Memo

Application Number: 162144

Address: BBC Caversham Park Peppard Road Caversham Reading RG4 8TZ

Proposal: Partial demolition of existing buildings, renovation and conservation of listed Caversham House (to facilitate change of use to C3 dwellinghouse use) and development of new residential (C3 use class) units.

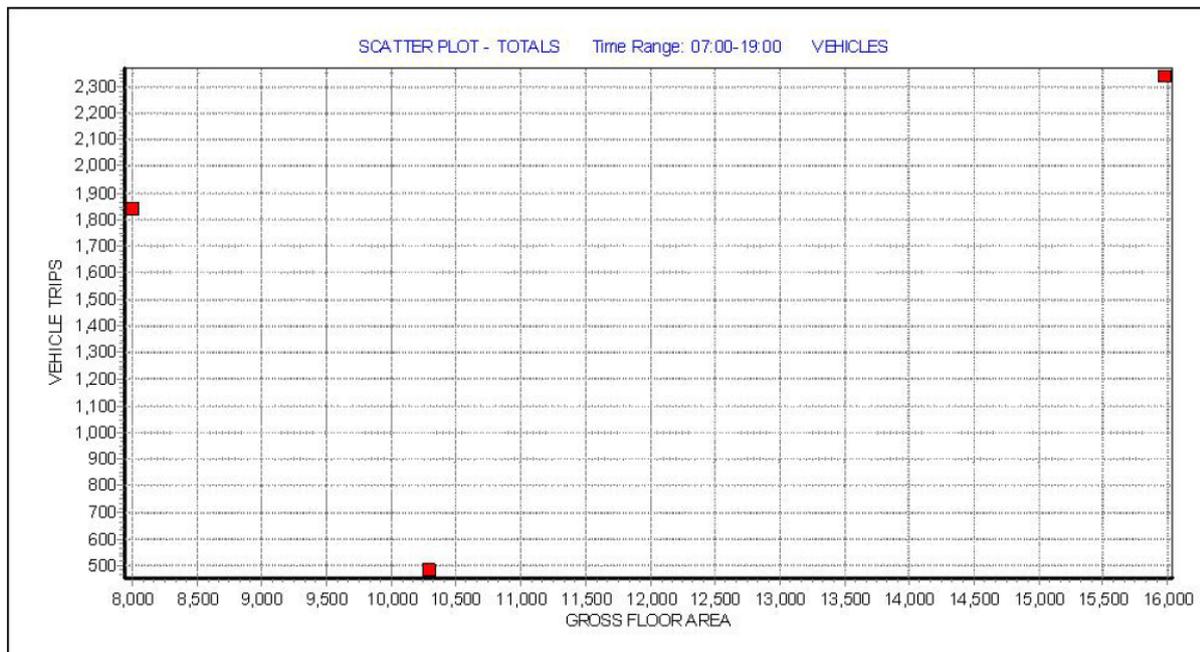
I have reviewed the parameters selected by the applicant and can confirm that they are acceptable. However, of the sites that have been selected I have concerns regarding two of them as they are provided with in excess of double the parking provision than that of the application site. This will result in inflated trip rates for the existing use and are therefore not comparable. This is highlighted by the scatter plot below.

Given that these two sites are unacceptable I am happy that the remaining site is used SC-02-A-17 to calculate the trips generated by the existing site and these illustrated in the table below.
